ORIGINATION FORM

Proposed Revisions to a Standard Plans Index (Please provide all information — Incomplete forms will be returned)

Index Number: 646-001
Sheet Number (s): ALL
Index Title: NEW: Aluminum Pedestals and Posts -
Pedestrian Detectors and Signals

| LAST REVISION 11/01/20 | REVISION | DESCRIPTION: |  | FY 2021-22 STANDARD PLANS | ALUMINUM POST AND PEDESTAL MOUNTED PEDESTRIAN DETECTORS AND SIGNALS | INDEX 646-001 | SHEET 1 of 1 |

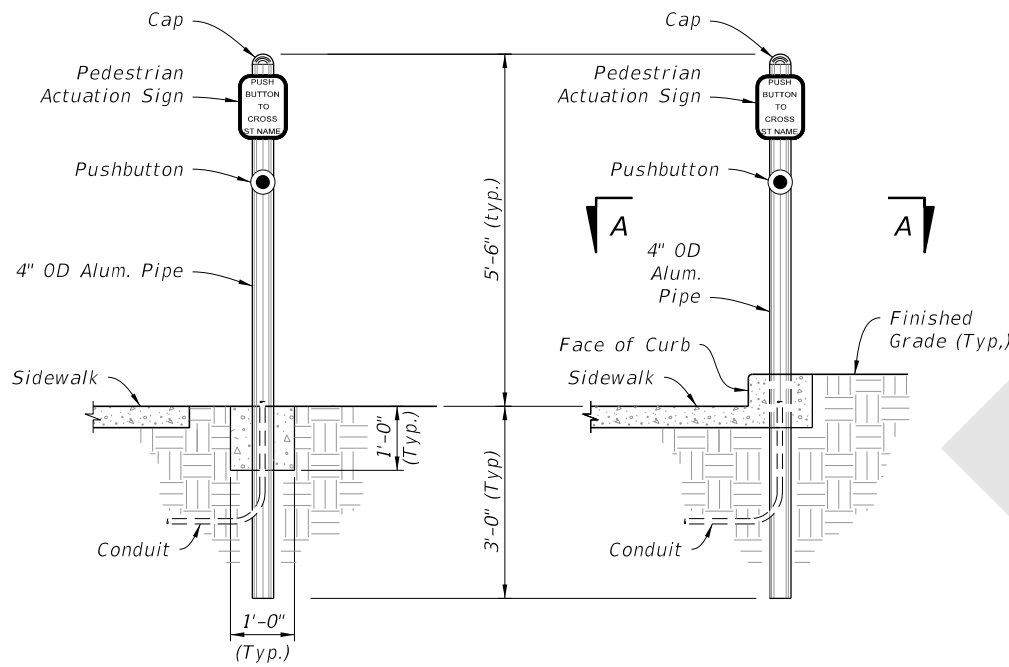
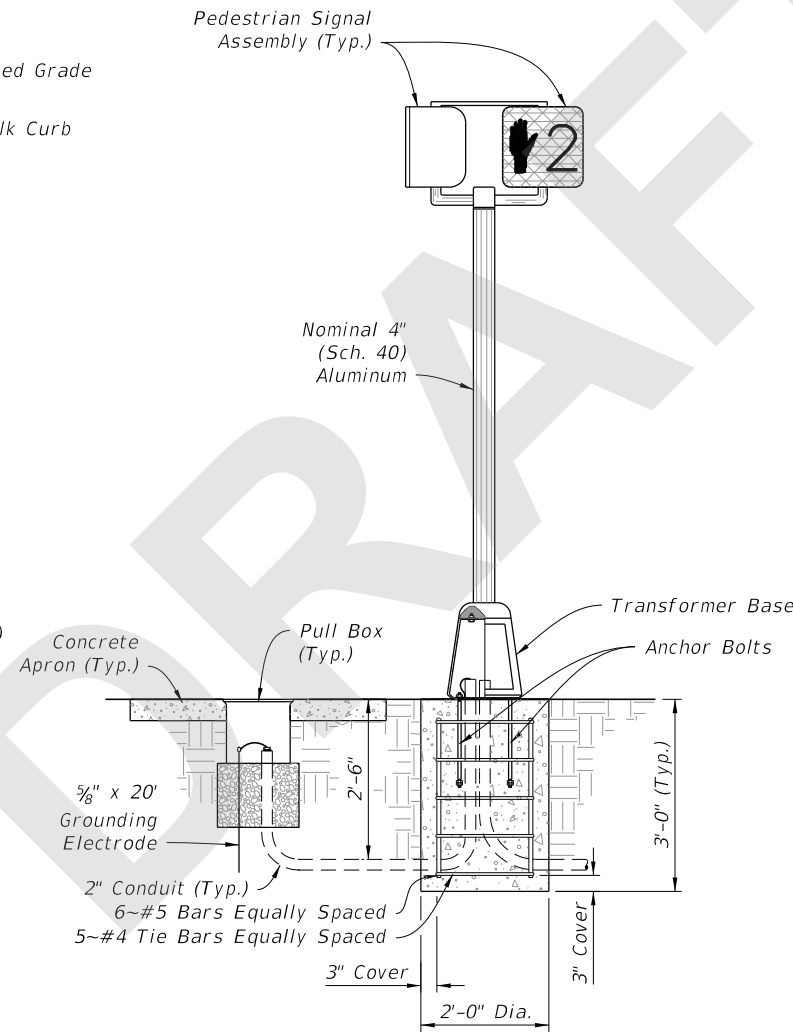
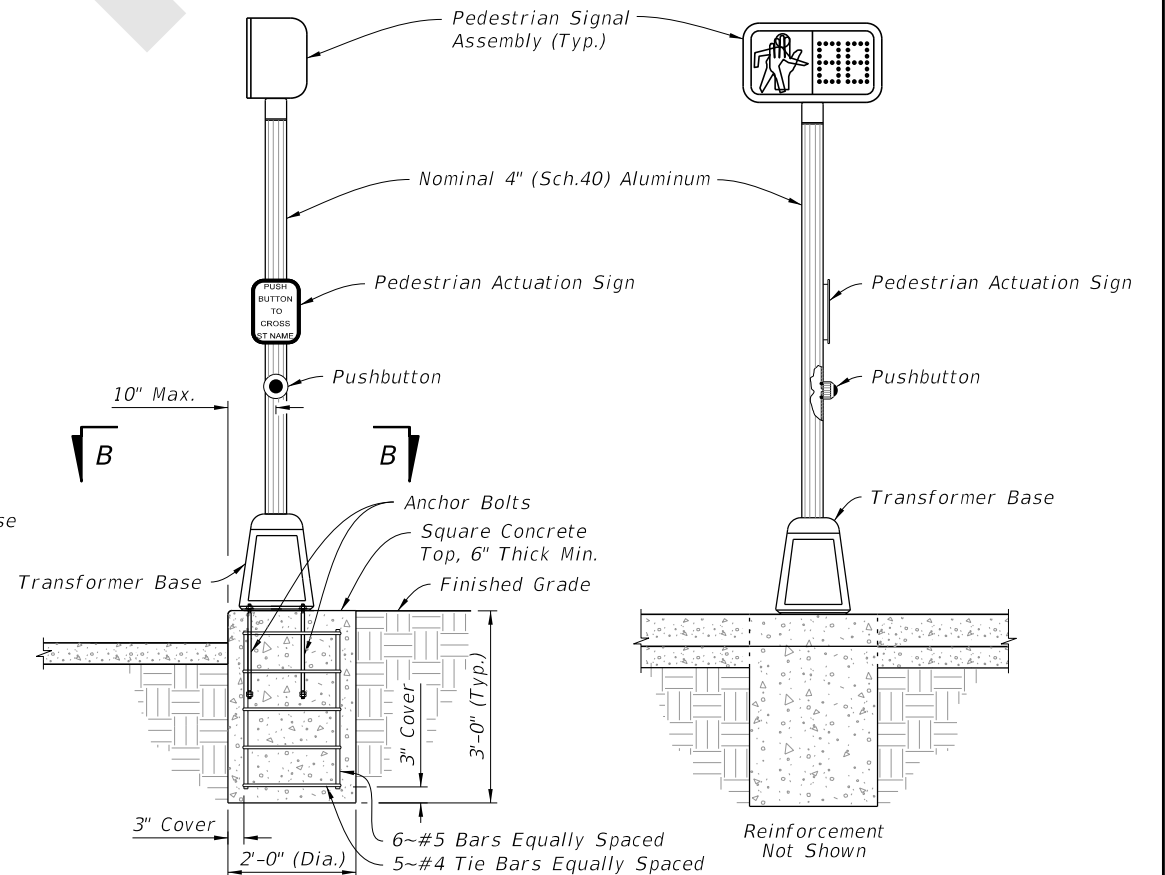
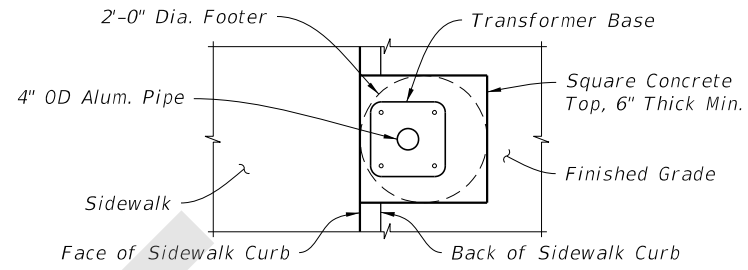
New Index created to consolidate the details of Aluminum Pedestals and Posts used for Pedestrian Signals and Detectors. Existing details are relocated in this New Index from Indexes 653-001 and 665-001. New details have been created to address the foundation and placement details for Pedestals installed with Sidewalk Curb. These were added to prevent pushbuttons from being located greater than 10" from the sidewalk landing.
